State of New Mexico
Energy, Minerals and Natural Resources
OIL CONSERVATION DIVISION
1220 South St. Francis Dr.
Santa Fe, NM 87505

Form C-103
Revised August 1, 2011

WELL API NO. 30-025-29686
5. Indicate Type of Lease STATE ☐ FEE ☒
6. State Oil & Gas Lease No.
7. Lease Name or Unit Agreement Name CH Weir A
8. Well Number: 19
9. OGRID Number 4323
10. Pool name or Wildcat Skaggs, Drinkard

Chevron USA INC respectfully request to abandon this well as follows:

Proposed Wellbore
CH Weir 19 # 1

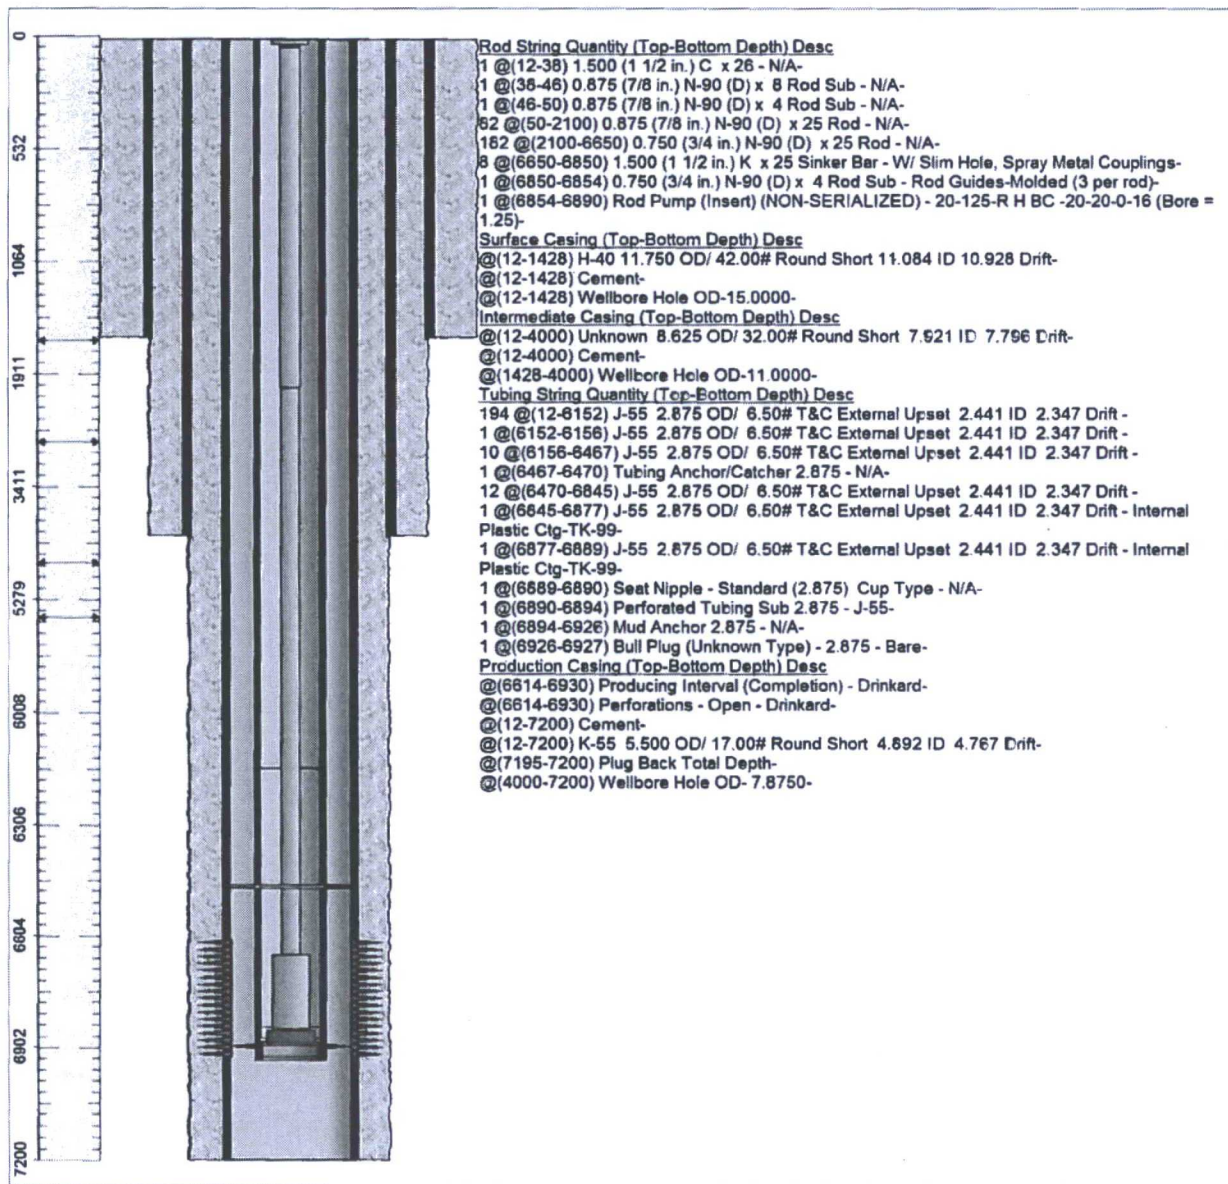
VERIFY CMT ALL STRINGS

NOTIFY OCD 24 HOURS PRIOR TO
BEGINNING PLUGGING OPERATIONS
